Application for Consideration of a Subdivision and/or Land Development Plan

RE: Preliminary/Final Subdivision Plan
For Duane Hernley
Waiver/Deferral Request
RETTEW Project No. 0092500245

Re: Preliminary/Final Subdivision Plan for Duane Hernley
Our File No. 10221-1

Re: Duane Hernley
Preliminary/Final Subdivision Plan
Township Permit No. 24-02-FSDP
LCEC Project No: 25-164

COVER SHEET
 PRELIMINARY / FINAL SUBDIVISION PLAN
 FOR
DUANE HERNLEY
 MOUNT JOY TOWNSHIP
 LANCASTER COUNTY, PA

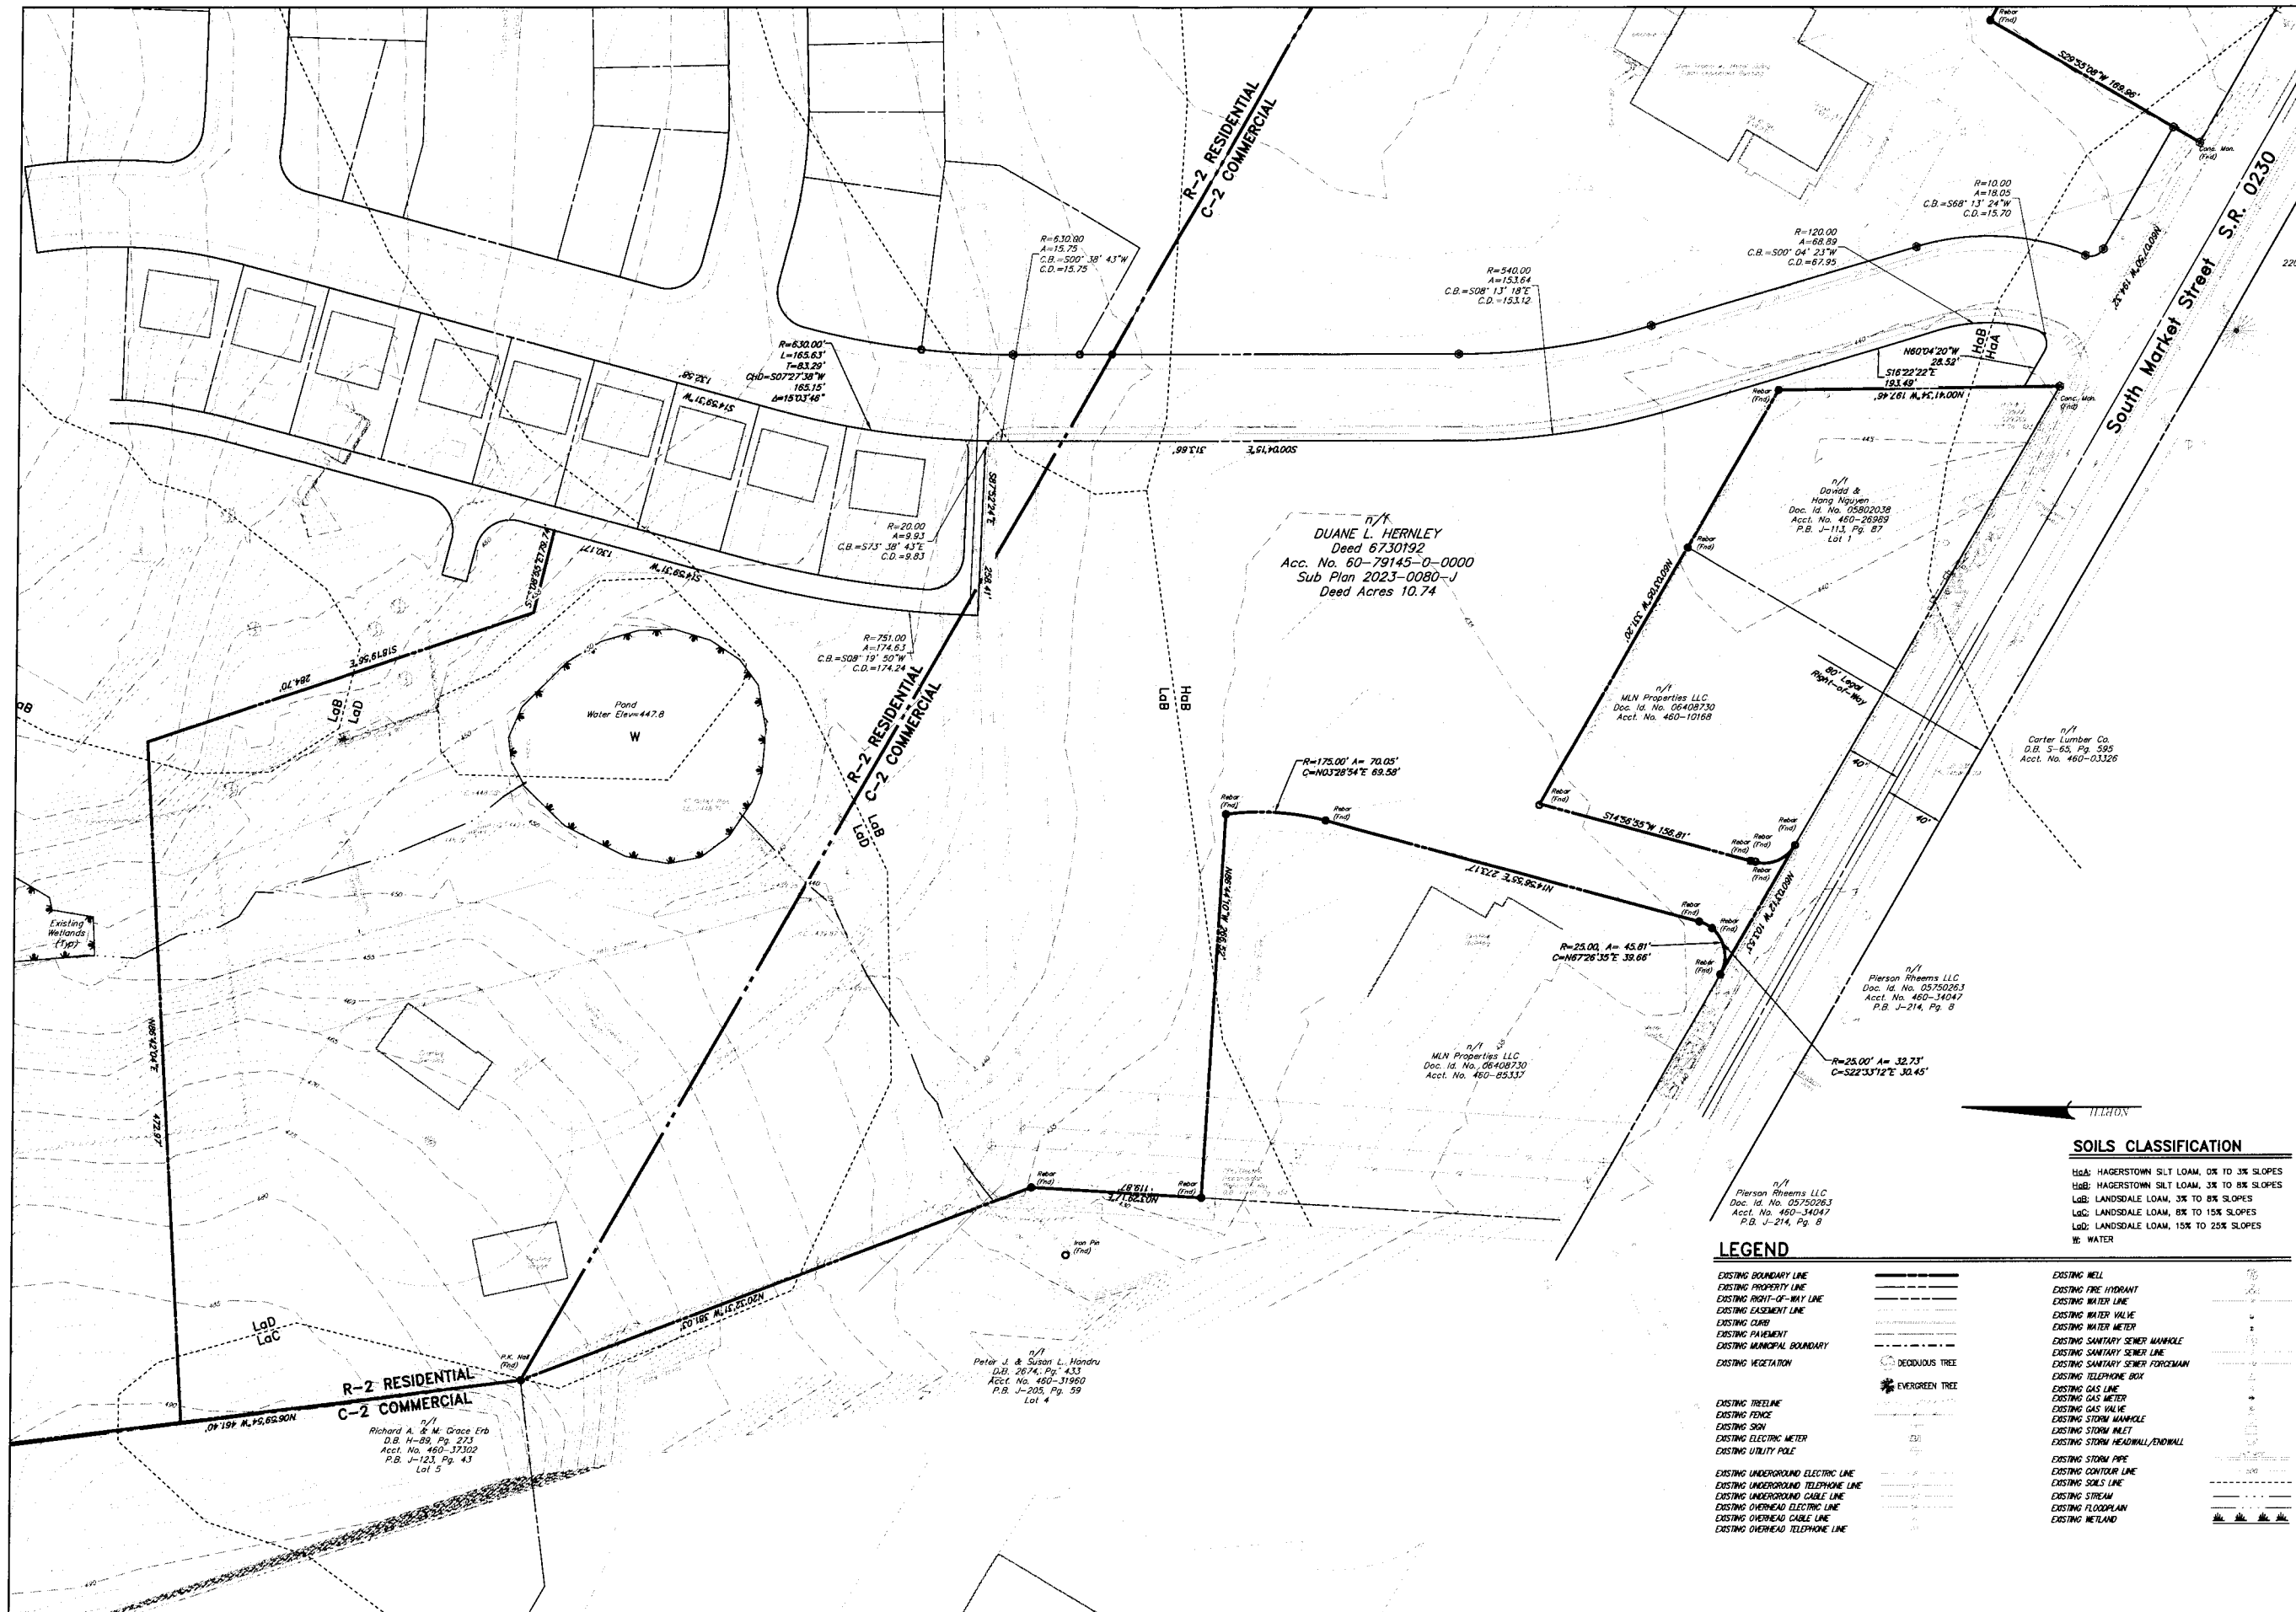
Rettew must proofread the Plan and remove inconsistencies. Under Source of Title on the cover sheet the land is identified as Lancaster County Tax Account No. 460-81630-0-0000, and the source of title is a deed recorded at Document No. 6194859. That tax account number and recording reference for the deed are from the Westbrooke Plan. General Note 4 has the correct Lancaster County Tax Account Number, 460-79145-0-0000, but General Note 5 has the incorrect recording reference for the deed. Sheets 2 and 3 of the Plan have the correct recording reference for the deed, Document No. 6730192, but the Tax Account Number is incorrectly listed as 60-79145-0-0000. All of these errors should be corrected.

The General Notes should be reviewed and clarified. General Note 10 is incomplete, and General Note 11 appears to be the end of the incomplete sentence in General Note 10. The same error is in General Notes 12 and 13. All of the General Notes should be reviewed and corrected as necessary.

14. The deed shown in Source Of Title and General Note 5 on the Cover Sheet and the tax parcel identification number shown on the plans shall be corrected (119-31.B(10)).

15. The bench mark described in General Note 6 on the Cover Sheet shall be labeled on the plans (119-31.C(1) & 113-43.I(1)).
16. The names and plan book record numbers of all adjacent landowners shall be shown on the plan, including those across existing rights-of-way (119-31.C(2)).

SUBMISSION PLAN
PRELIMINARY / FINAL SUBDIVISION PLAN
FOR
DUANE HERNLEY
 MOUNT JOY TOWNSHIP
 LANCASTER COUNTY, PA

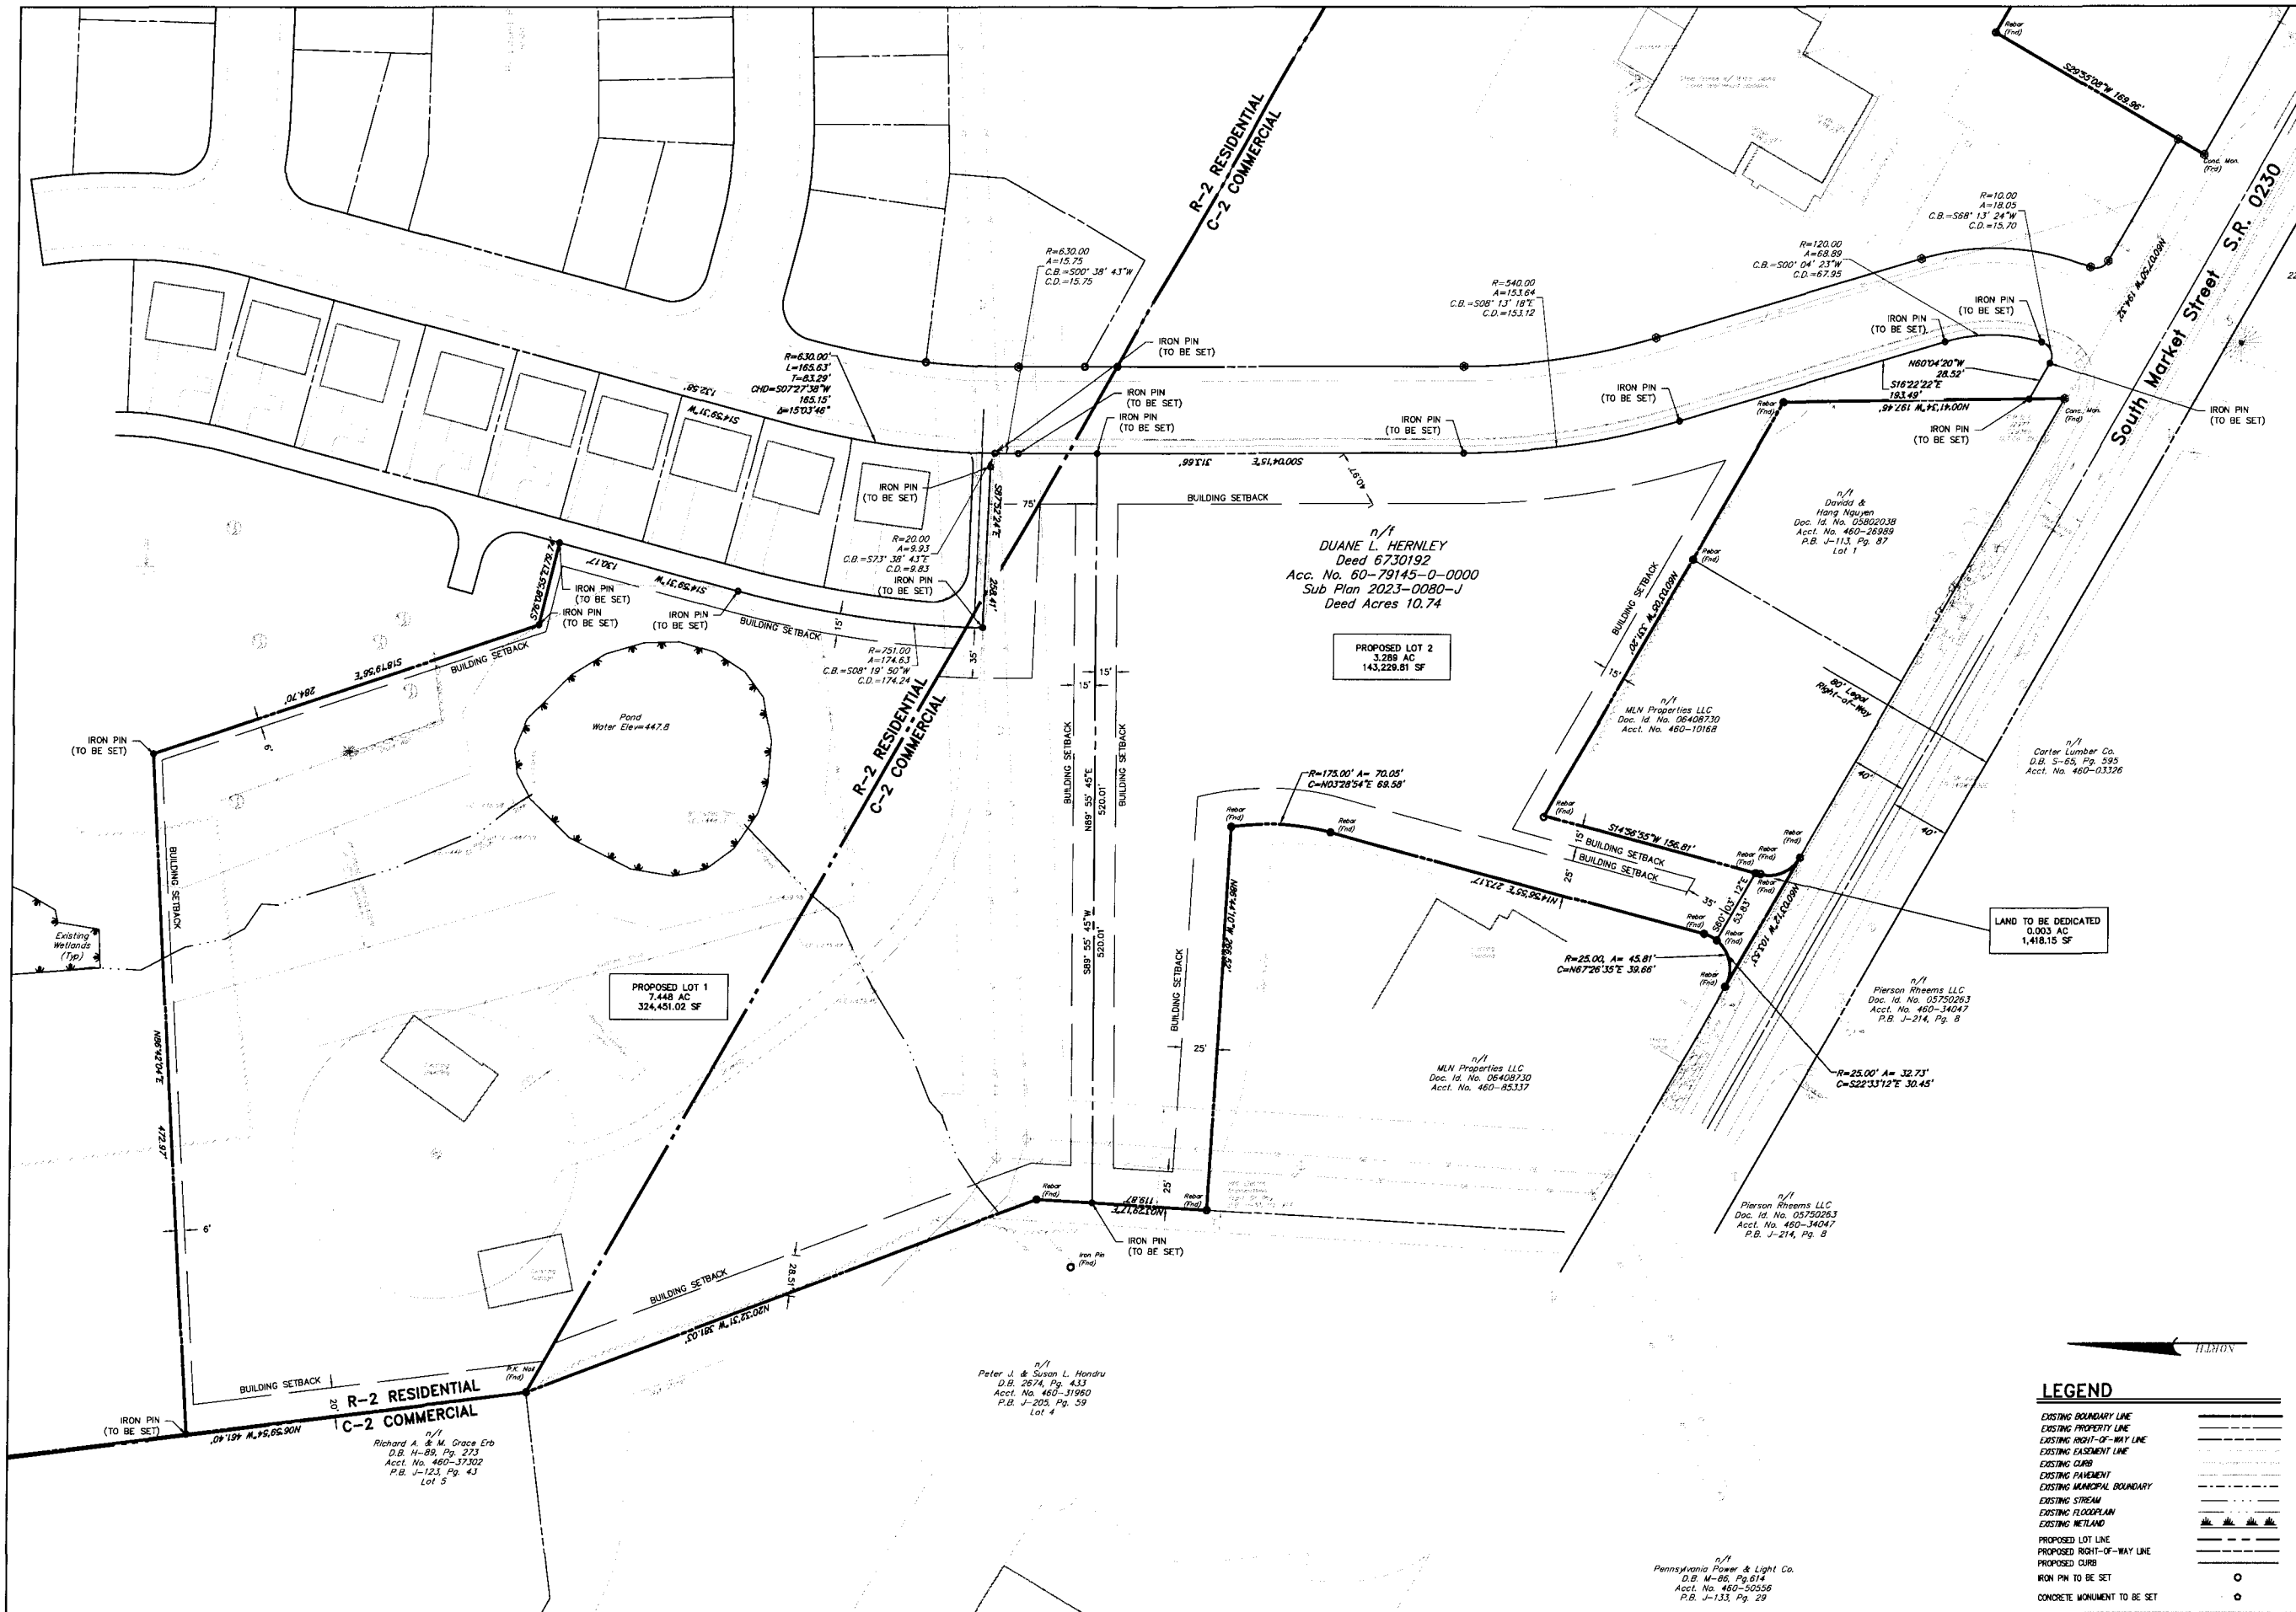
25. The dimension of the front yard setback for Proposed Lot 2 shown on Sheet 3 shall be corrected (119-31.D(5) & 119-55.A).
26. The plans shall indicate when the lot line markers are to be set (119-31.D(14)(a) & 119-57.D).
